Wizards Workshop

TEKTRONIX INTERNAL USE ONLY

July 11, 1980
Issue 10-14

413 POWER SUPPLY KIT

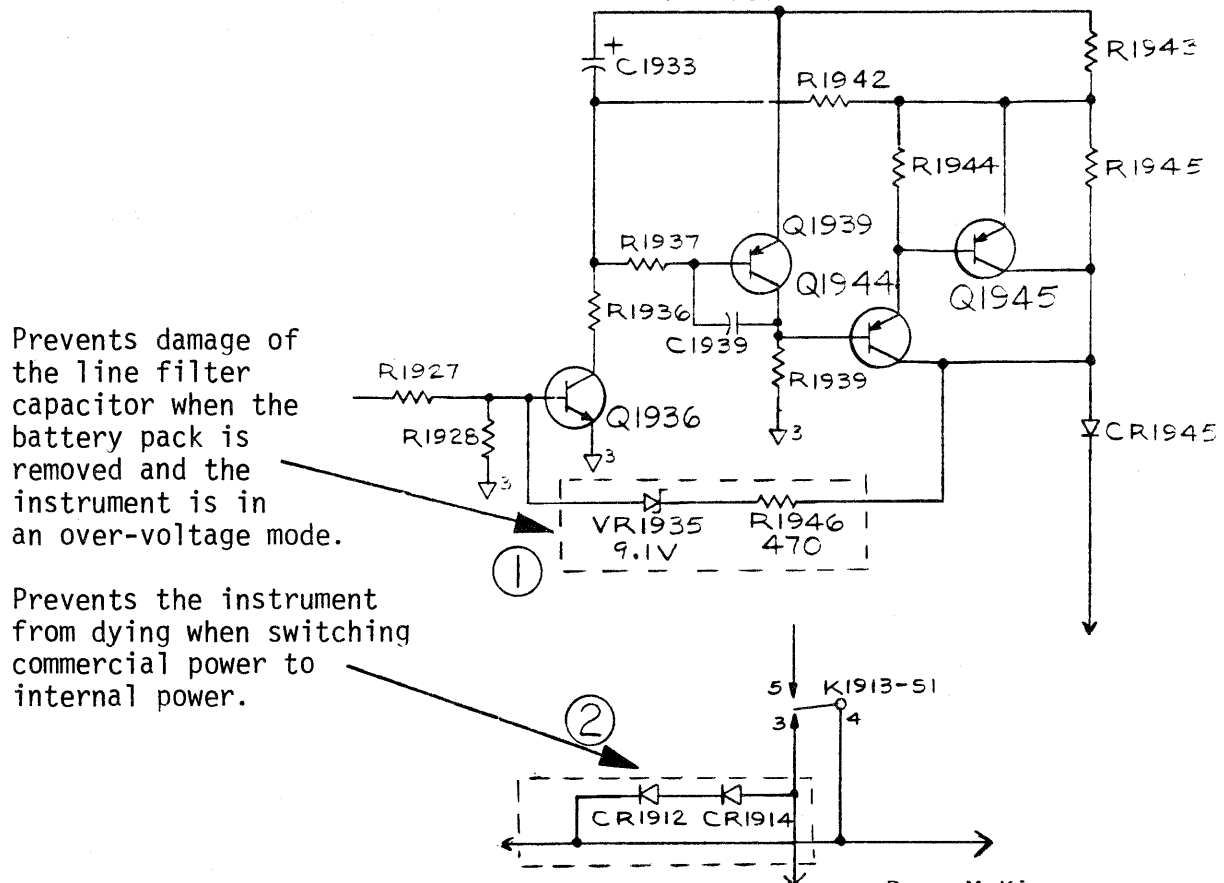
To incorporate the mods below on the 413 Medical Monitor, S/N B010100 - B049999, refer to the Kit P/N 040-0961-00. Manufacturing is implementing the change effective S/N B050000.

Refer to the picture for location of changes:

CIRCUIT NUMBER	PART NUMBER	DESCRIPTION
CR1912	152-0198-00	Semiconductor; Silicon, 200V, 3A, 1N4721
CR1914	152-0198-00	SAME AS ABOVE
R1946	315-0471-00	Res., FXD, CMPSN, 470 Ω , 5% 0.25W
VR1935	152-0306-00	Semiconductor Device Zener, .4W, 9.1V, 5% 1N960B

520A/ PART NUMBER FOR SLIDE DOOR TRACK SPACER

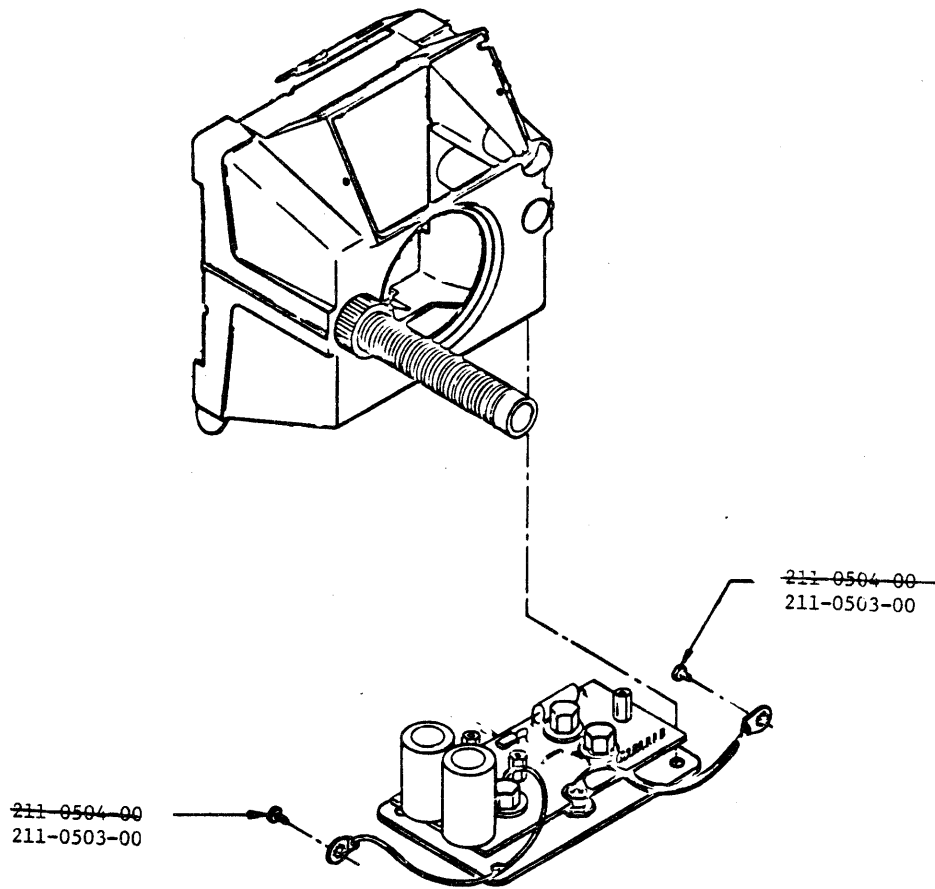
Figure 1 (Front) of 520A manual does not include the spacer for the slide track. The 521A manual does show this part (item 115). The part number is 361-0232-00. A manual correction form has been submitted.

Figure 1 P/O A1 Processor Board
(Front View)

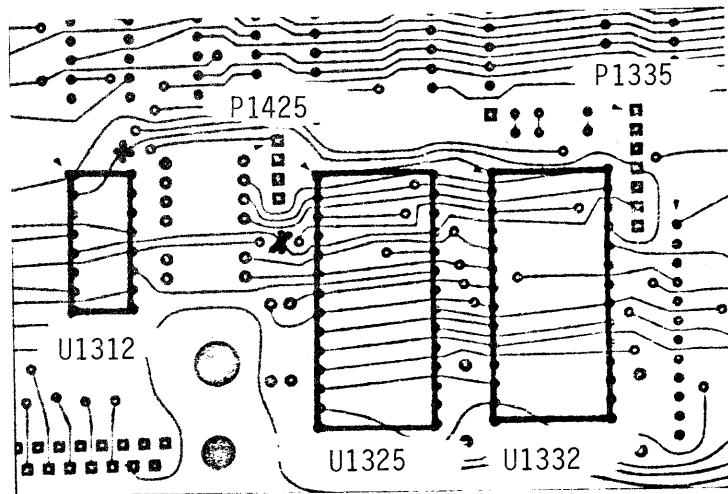
There still appears to be a need for additional information to clarify the steps which require the cutting of circuit board runs. Please refer to Figure 1. One step requires the cutting of a run between U1332-9 and U1325-25. This run is easily identified on the rear of the Processor (A1) board and is not illustrated. Another step requires the cutting of a run between U1312-2 and P1335-4. This is illustrated just above U1312 in Figure 1 or you can cut the run near P1335, Pin 4. The other step is to cut a run between U1312-5 and U1325-25. This can be accomplished by cutting the run just to the left of U1325, Pin 5 which is at a forty-five degree angle, see Figure 1.

A request is being made to include Figure 1 in the next version of the Current Loop (Option 2) Field Mod Kit, Part Number 040-0897-00.

221 TRANSFORMER SHIELD ASSEMBLY CORRECTION

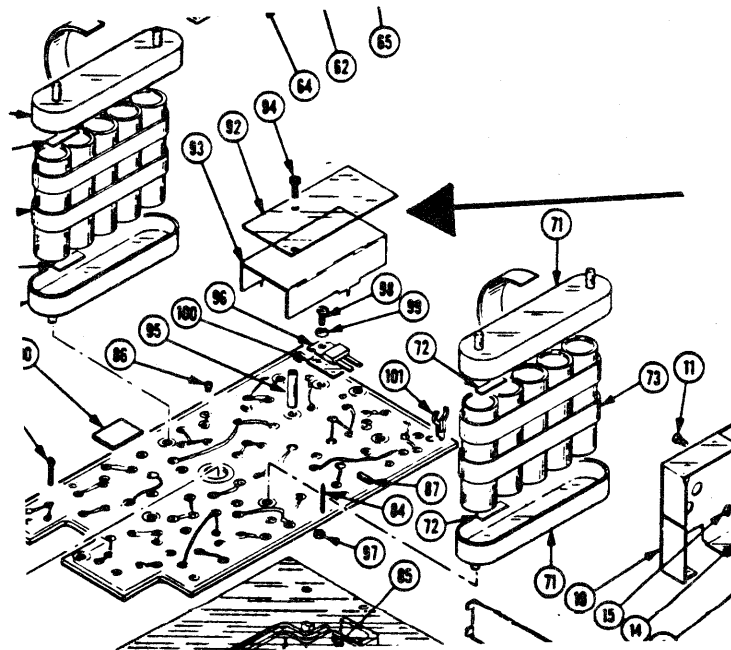
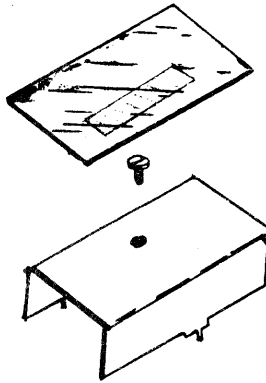
The mechanical parts exploded view illustrates the assembly of the transformer shield with the screw going through a hole in the insulator film and through the shield into a spacer post. This assembly is not correct and is pictured incorrectly in the manual as shown in Fig. 1. The Mechanical Parts List calls for a nylon screw; however, the nylon screw has never been used in regular production due to stripping. A metal screw has been and is now being used.

If the shield is assembled wrong, the screw head--which is secured in the post which has A.C. line on it--will short to the CRT shield, which is at probe ground. It is then possible for A.C. line to be present on the ground clip of the probe. If for any reason the shield is removed, make sure upon reassembly the screw head is covered with the insulation film.

The correct assembly has the screw going through the transformer shield only. The screw used is a metal screw, P/N 211-0087-01. The insulator film is placed over the shield and screw, and is held in place with double side tape, P/N 006-1342-00 as illustrated in Fig. 1B.

The insulator film has been modified by removing the hole so there will be no temptation to insert the screw through the film. The new number for the shield is P/N 342-0213-01. If the old film is used, make sure the hole in the insulator film is rotated so that it is not over the head of the screw.

All 221's have been assembled correctly in the plant. The error is with the exploded view, which has always been drawn incorrectly. As of this publication, the manual has been corrected and all new manuals will show the correct assembly and part numbers.

4907 POWER SUPPLY MODIFICATION #40319

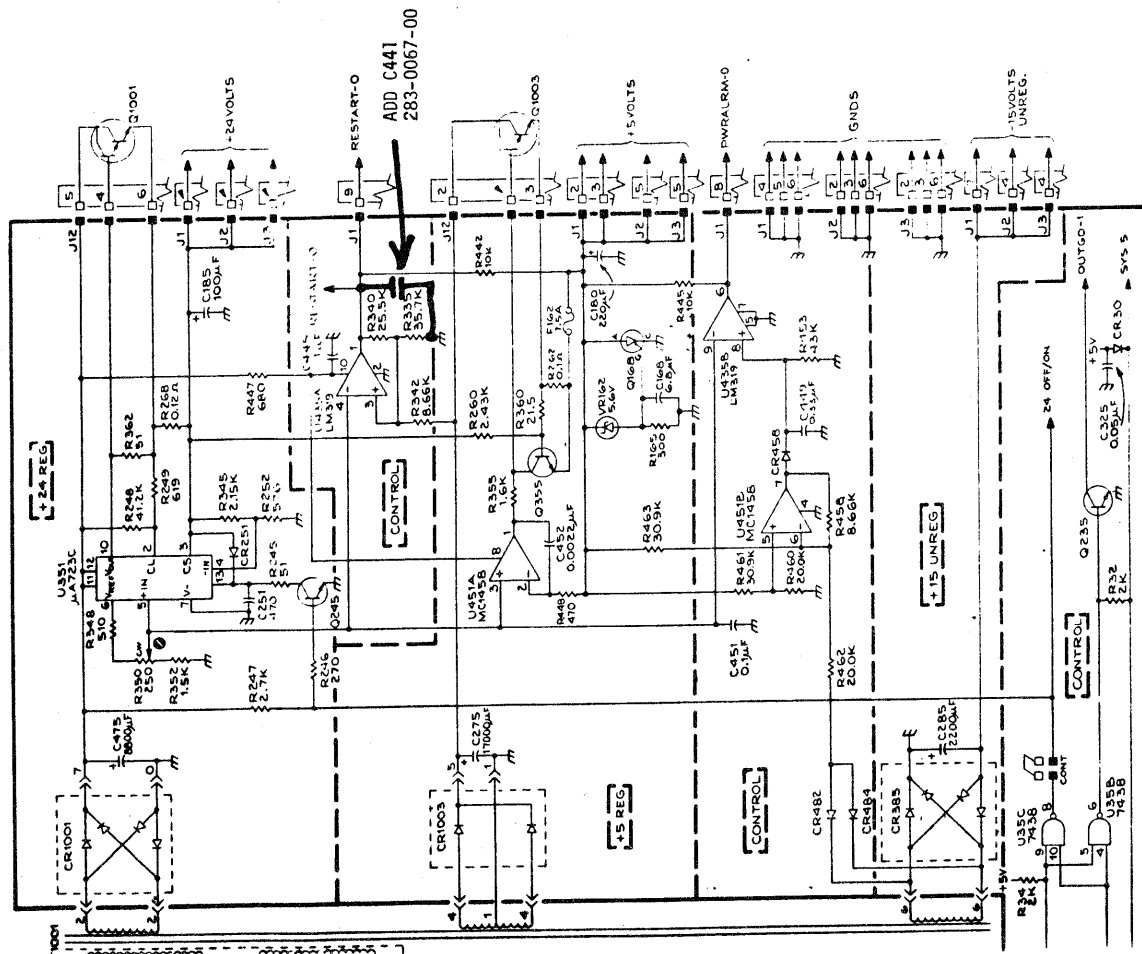
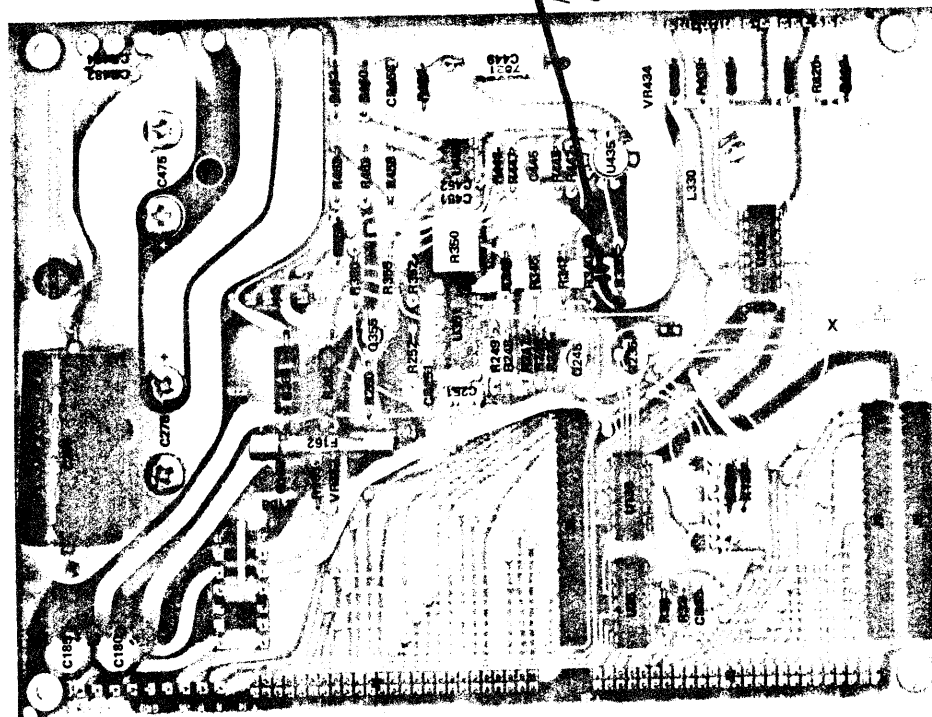
There has been a reliability modification to the 4907 Power Supply (P/N 670-5441-02) which will decrease its sensitivity to line voltage transients. The modification is corporate MOD #40319.

1. Remove line filter A1001 (119-0873-00) from the unit
2. Replace A1001 with a 119-1330-00
3. Remove transistor Q1001 (151-0656-00) and insulator (342-0328-00) from the rear panel.

4. Replace Q1001 with a 151-0606-00, use the mica insulator which comes with the 156-0606-00 instead of the 342-0328-00.
5. Add capacitor C441 (283-0067-00) to the Power Supply Board (670-5441-02) from the grounded end of R335 to the end of R340 which is connected to pin 1 of U435. Refer to Figure 1 & 2.

6. Replace the cable assembly that runs from J12 on the power supply to Q1001 and Q1003 on the back panel with 22 gauge wire (175-0859-00). Six harmonica connectors 131-0621-00 will be needed to make the connection to the Power Supply's J12. Solder the cable leads to the back panel transistors. (refer to Wizards Workshop Issue 10-5 March 7, 1980, page 45 - "4907 POWER SUPPLY CABLE PROBLEM" for more background on this step).

PROCEDURE FOR CLIP AND SOLDER UPDATE OF D1B SECTOR CARDS

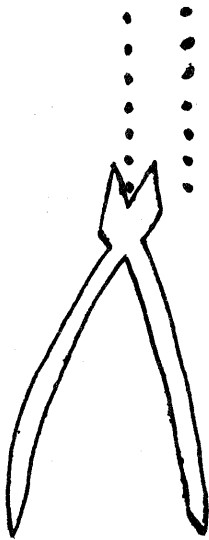
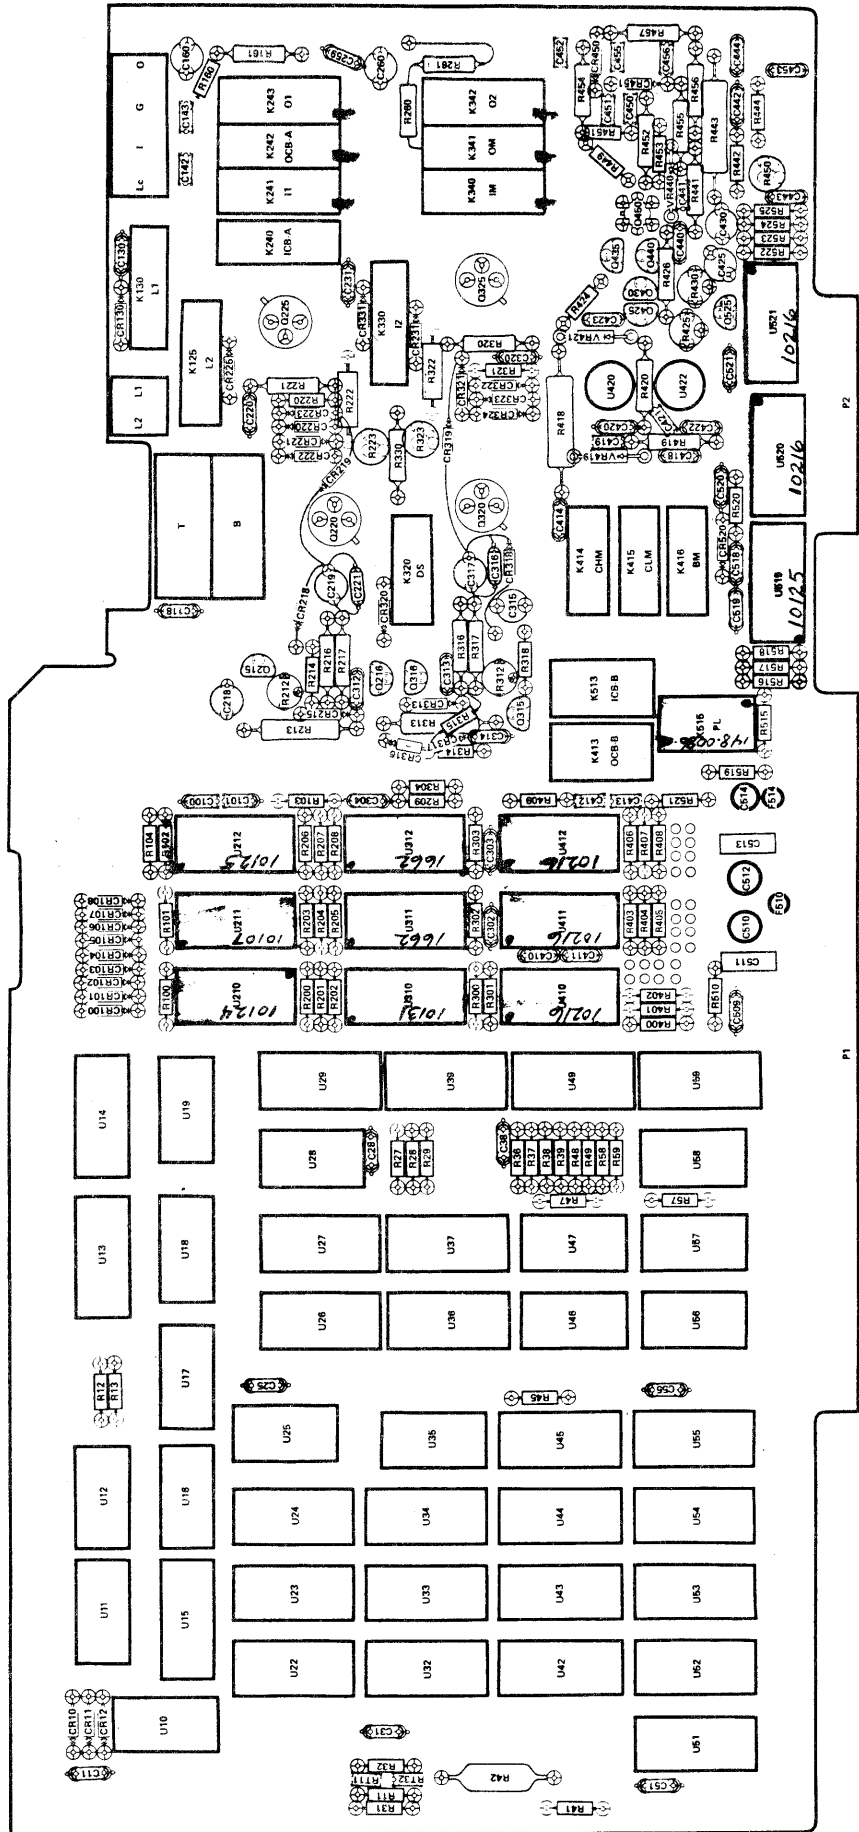
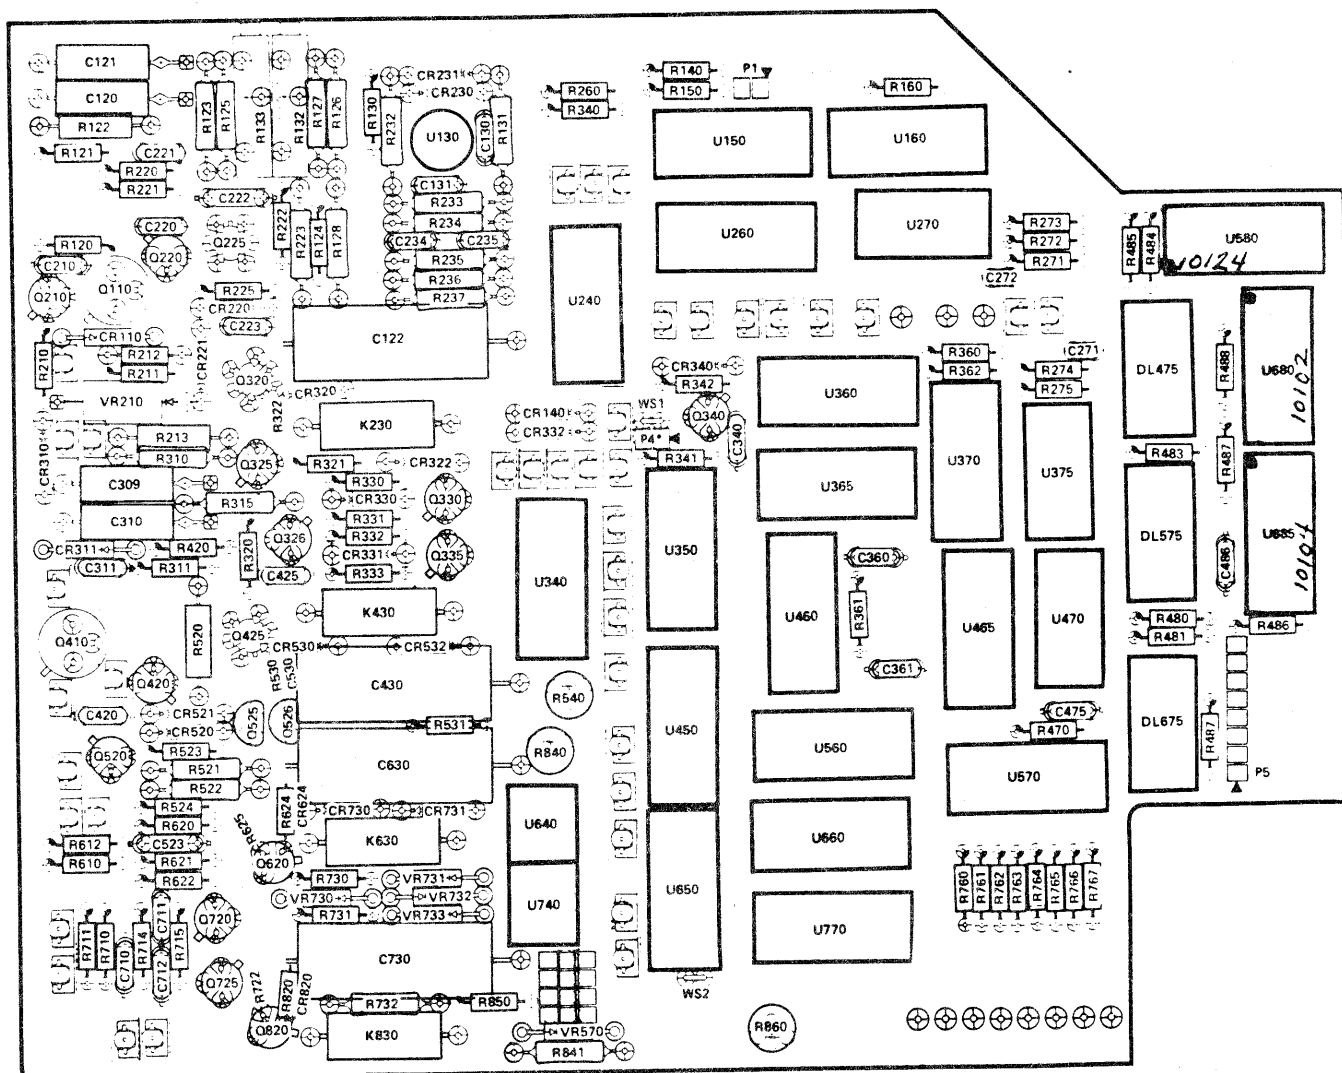
The following parts placement diagram indicates the primary IC's to be soldered in along with the power transistors Q21 and Q41. The older type sample holds without Expect Data Delay will not be involved in this procedure.

6. Clip the sockets as close to the pads as possible. Work lengthwise to the row of sockets as shown in the diagram. This will permit easier insertion of the IC.

13. In addition, the reeds indicated on the diagram IM,OM, 02, etc. are susceptible to poor solder joints on the signal path lead due to a contaminated surface before the connection is made or to insufficient heat being applied when the connection is made to the large pads. I suggest you pick at the reed signal path connections with a scribe. The poor connections will come loose without much difficulty leaving a dark tarnished surface on the pad. This is rosin, and should be cleaned off before the new connection is made using FOTOCAL or equivalent. Resolder these using plenty of heat and solder.
